**Service Bulletin**

File in Section: 06 - Engine Bulletin No.: 12-06-01-009B Date: March. 2013

Subject: Information on High Feature V6 Timing Chain Kits and Chain Guide Replacements, DTCs P0008, P0009, P0016, P0017, P0018 and/or P0019

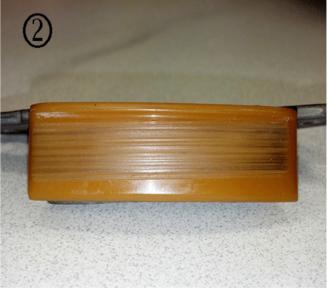
When replacing timing chain kits, the timing chain guides should not always be replaced; they should only be replaced in cases where the guide wear block surface is worn down into the base friction material, leaving friction wear witness marks. Refer to the above pictures showing an example of normal wear (1) which should not be replaced, and a worn guide (2) which should be replaced.

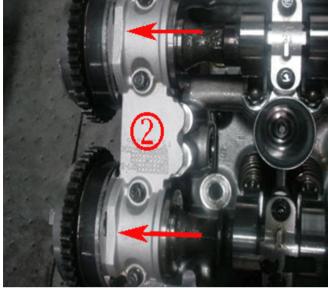
While the engine is disassembled, refer to Global Warranty for the vehicle build date. If the vehicle was built before 06/05/2009, also inspect the camshaft saddle caps.

If the subject cylinder head is of the 2nd design shown above (2), no further action is required for this section of the bulletin listed as part B.

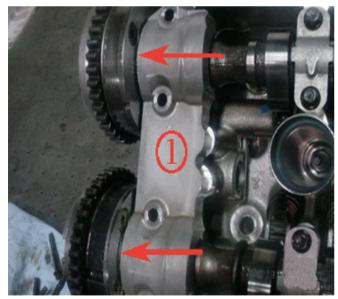
For 1st design shown below, visually inspect for teflon camshaft thrust washers being present between the camshaft actuator and the saddle cap. 1st design (1) is for both intake and exhaust. Refer to the examples below:

Inspection of the 1st design Saddle Cap with no Teflon washer present

Install one camshaft thrust washer between each camshaft and actuator if not present.
